Lehigh Southwest Cement Company

April 15, 2010

Subject: Re: NOTICE OF VIOLATION and required corrective action for failure to protect stormwater at industrial facility

Facility: Lehigh Southwest Cement Co. (formerly Hanson Permanente Cement) Industrial facility, located at 24001 Stevens Creek Boulevard, Cupertino, Santa Clara County
WDID No. 2 4310062677

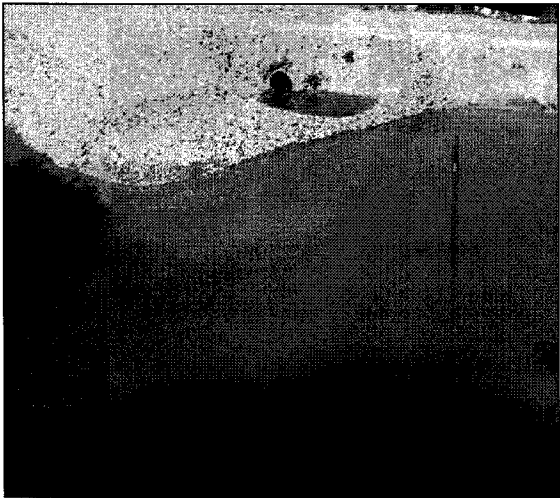
3. INSPECTION FINDINGS: A visible discharge of pollutants sediment and/or other pollutants into Permanente Creek was observed during inspection, as described below. Adequate BMPs were not implemented to prevent discharge of pollutants from Pond 17 the southeast portion of the site, down-gradient of the Rock Plant.

Pollutants were being actively conveyed the Rock Plant (see attached Photographs 8) to the Pond 17 inlet. Pollutant accumulation was present along the entire inlet portion Pond 17, including evidence of a high event that had caused the inlet check dams breach (see attached Photograph 9).

Moreover, pollutant-laden flow was observed passing over the outlet weir section (see attached Photographs 10 and 11) and through the outlet pipe (see attached Photographs 12 and 13). As specified in Figure 2 of SWPPP 14, the Pond 17 outlet is connected to an outfall to Permanente Creek below Dinky Shed Basin. The Pond 17 outlet flows to a drainage vault (see attached Photographs 14 and 15), which then discharges at the outfall to Permanente Creek. Pollutant-laden flow was observed at the outfall (see attached Photograph 16), and in the Permanente Creek receiving water (see attached Photograph 17 through 19).

As a result, there was an active pollutant-laden discharge during the inspection. Because Pond 17 was not functioning as an adequate BMP for pollutant removal, either the pond must be modified to provide additional filtering and settling of pollutants, or adequate BMPs must be implemented for the pollutant generating sources at the Rock Plant to reduce pollutant conveyance to the pond, and prevent the subsequent discharge of pollutants to Permanente Creek.

REQUIRED CORRECTIVE ACTIONS: By April 15, 2010, select, install, implement, and maintain BMPs to meet BAT and BCT to eliminate discharge of pollutants from Pond 17 into Permanente Creek. In order to come into compliance, you may need to implement temporary BMPs and later come back in and implement more permanent measures. Revise the Facility's SWPPP to document updates, and submit a paper and electronic copy to the Regional Water Board.

Lehigh Response: One of the storm water BMPs implemented to protect industrial discharges from entering Permanente Creek, as stated and implemented in SWPPP plans (most recent revision SWPPP 15, submitted to the Board on March 3, 2010) involves directing stormwater that contacts the operational facilities to retention ponds. These retention ponds allow for sediment carried via the stormwater streams to be settled out before the water is discharged to the creek. Pond 17, located Southeast of the aggregate facility located at the Permanente site (Rock Plant), is situated such that stormwater that may contact the lower portion of this facility would be directed to this pond for potential sediment control.

Pond 17 was cleaned out in the 2009 dry season, consistent with past practice. The frequency and intensity of the storms in late January/early February 2010 led Pond 17 to be completely filled with sediment just prior to the February inspection. The February 10th, 2010 inspection occurred before any pond sediment removal activities could be completed after conditions allowed following the most recent storm. However, these pond sediment removal activities were initiated on February 16th and completed on February 19th, 2010. As is consistent with all pond sediment

Pond 17 was completely cleaned out with the sediment removed and, as a function of stormwater quality, currently produces a very clean discharge. Please see the pictures below, reflecting post-cleanout Pond 17 water quality.

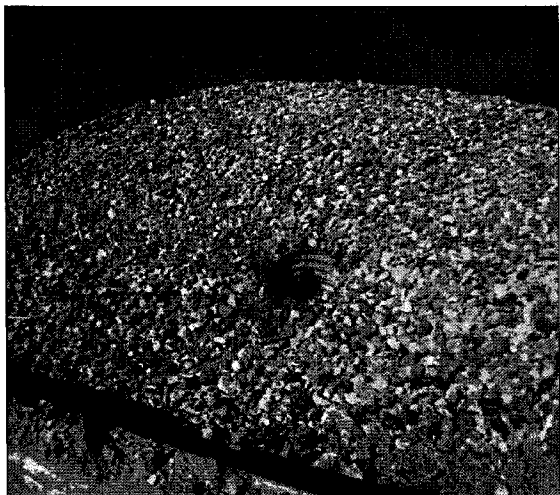
4. INSPECTION FINDINGS: The EPA Contract Inspector observed, during the inspection, that the Pond 9 BMP was not adequately inspected and maintained to prevent the discharge of sediment from the upgradient sediment generating sources in Drainage Area D to Permanente Creek. Table 6-1 of SWPPP 14 shows that the contributing area for Pond 9 is Drainage Area D, which includes the Rock Plant Road.

Sediment accumulation was present at the southwestern inlet to Pond 9, and sediment was being actively conveyed from the Rock Plant Road to the southwestern inlet to Pond 9 (see attached Photographs 20 and 21). Sediment-laden water was present in Pond 9, and erosion was observed at the northeastern inlet which lacked flow dissipation BMPs (see attached Photograph 22). As specified in Figure 2 of SWPPP 14, the Pond 9 outlet is connected to an outfall to

The Environmental Manager explained that maintenance of Pond 9 had been restricted by regulatory agency actions in the past, but maintenance of Pond 9 was re-instituted in 2007. As a result of the sediment accumulation and sediment-laden water present in Pond 9, there was a potential for the discharge of sediment to Permanente Creek. BMPs must be adequately inspected and maintained to reduce sediment conveyance to the pond from the sediment generating sources in Drainage Area D, and prevent the subsequent discharge of sediment to Permanente Creek.

REQUIRED CORRECTIVE ACTIONS: By April 15, 2010, select, install, implement, and maintain BMPs to meet BAT and BCT to eliminate discharge of pollutants from Drainage Area D and Pond 9 into Permanente Creek. Please note that restrictions imposed by regulatory agencies for the dredging of these or other ponds does not prevent the facility from selecting, implementing, and maintaining appropriate and effective BMPs. In order to come into compliance, you may need to implement temporary BMPs and later come back in and implement more permanent measures. Revise the Facility's SWPPP to document updates, and submit a paper and electronic copy to the Regional Water Board.

Lehigh Response: Pond 9 receives stormwater that come into contact with aggregate customer bulk trucks and plant mobile equipment. The pond is designed to retain this storm water allowing potential sediment to dropout before moving to the discharge standpipe. Additionally, the pond structures a limestone material around the discharge standpipe for further sediment control and water "polishing" prior to discharge. The recent frequency and intensity of the storms in late January / early February 2010 resulted in the inlet of Pond 9, only one of the five roadway inlets, to be filled with sediment. Pond 9 was inspected late in January and, at that time, was holding up well. At the time of the inspection the pond still retained retention capacity to allow for sediment dropout. However, it was noted that the limestone filter material had fallen away during the most recent storms prior to the February 10th, 2010 inspection.

Because of contractor scheduling delays and storm events the scheduled Pond 9 clean out will be carried out the week of April 19, 2010.
